Yamada Bulletin

No. 2016-05

CHANGE OF HAND GREASE GUN

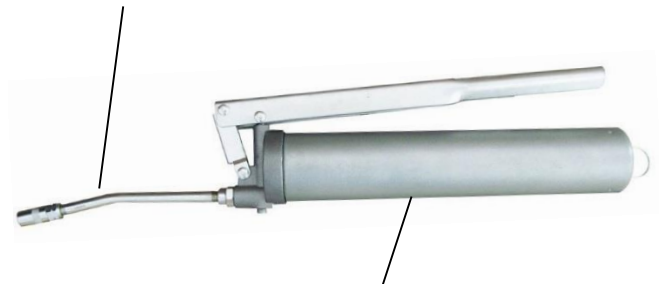
Current CH-400

Straight steel extension HSP-2

Barrel with non-lipped follower for use only with 420mL Bellows Cartridge Grease

New CH-400EX

***The spec is carried over from KH-500**

3-jaw steel extension CNP-2

Barrel with lipped follower for use with both 500mL direct-fill and 420mL Bellows Cartridge Grease
